Staff Presentation to the
Portland Design Commission

Design Review Hearing
EA 15-119801 DAR
Grant Park Village III

April 14, 2016

Ground Floor Active Use

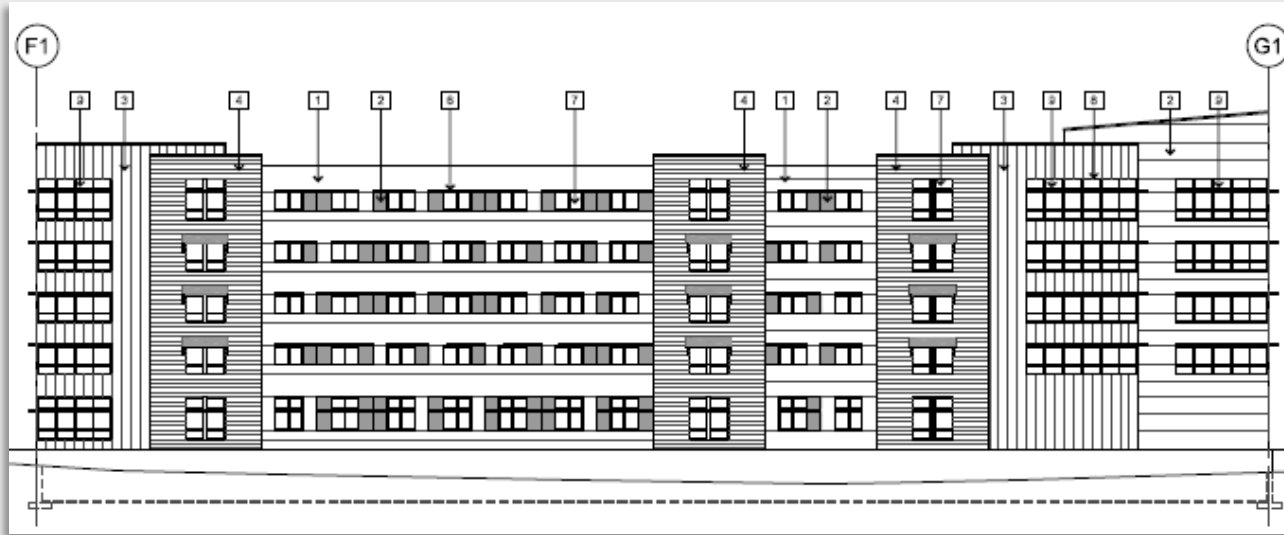
As proposed, the building is built to the north property line and the ground floor program lacks any inducement to sidewalk activity due to internally accessed inactive floor area – garage access, porte-cochere, office and conference room, and trash room fronted by an exterior loading stall. Abutting the Sullivan’s Gulch Access Easement. Approval Criteria: E3 Sidewalk Level of Buildings; D2 Main Entrances; D5 Crime Prevention.

Staff Advice: Staff advises that a 15’ setback be required to accommodate the necessary pedestrian facilities intended by such an **access** easement.

Building Materials

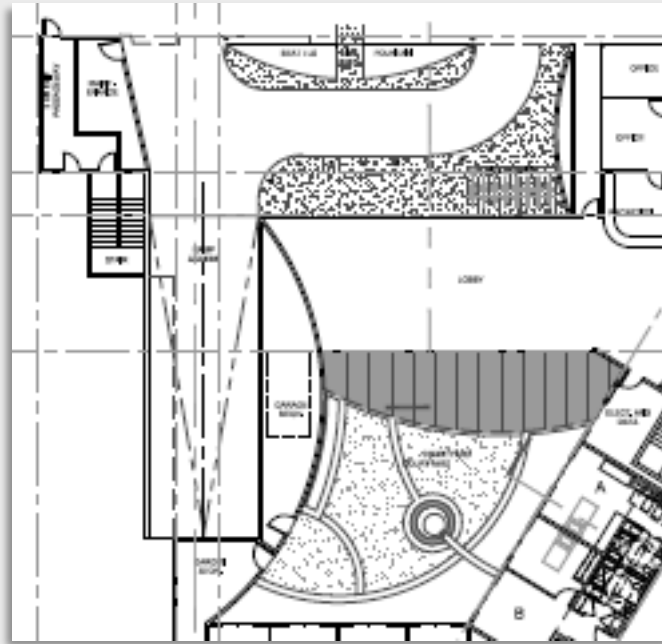
High quality building materials are expected for this development fitting into the overall site as a comprehensive part of Grant Park Village. Cladding materials are proposed to be metal panel, stucco, exposed concrete, vinyl windows and aluminum storefront. Approval Criteria: D7 Blending into the Neighborhood; D8 Interest, Quality and Composition.

Staff Advice: *Simplify palette into a more coherent overall appearance; a true three-coat stucco; metal panel – 22 ga backed/concealed fasteners; windows – VPI vinyl or better; PTAC grilles must be well integrated into the exterior; and, rooftop equipment should be screened with enclosures.*

Parking Areas

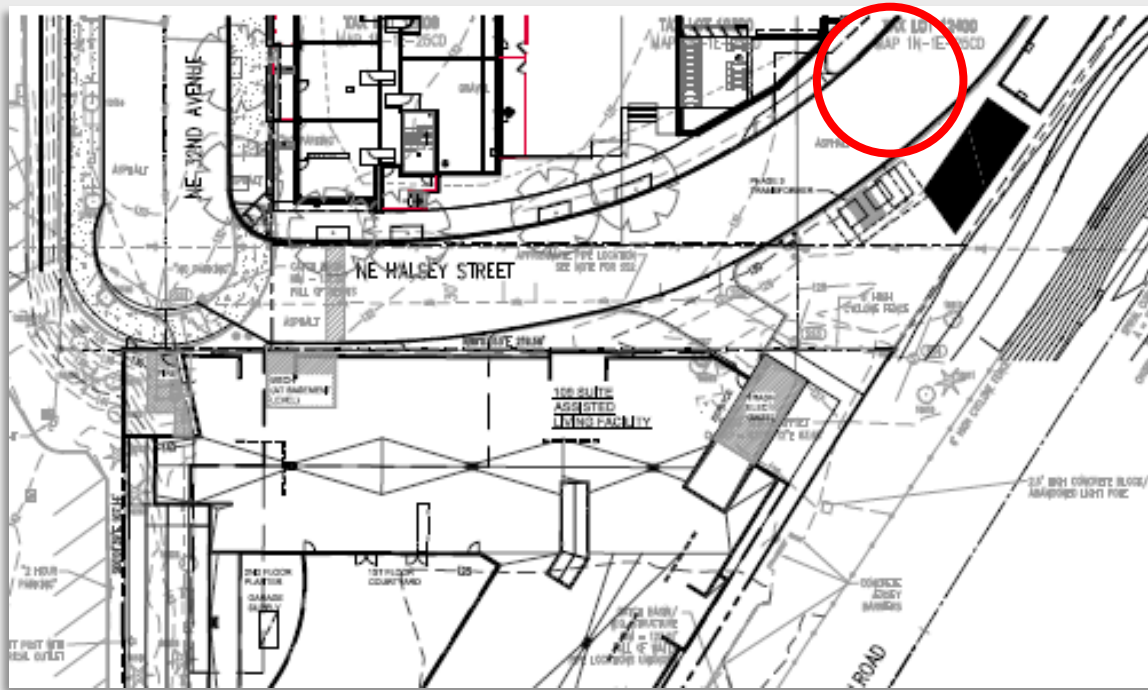
The project's only public frontage (NW corner) features garage access and porte-cochere. Per Table 266-3, vehicle areas are not allowed between the building and the street. However, because the frontage is not public ROW, this standard does not apply. Approval Criteria: E1 Pedestrian Network; E4 Corners that Build Active Intersections.

Staff Advice: *Staff advises the Applicant study a design solution orienting parking garage access to somewhere other than the project's only public corner at the NW.*
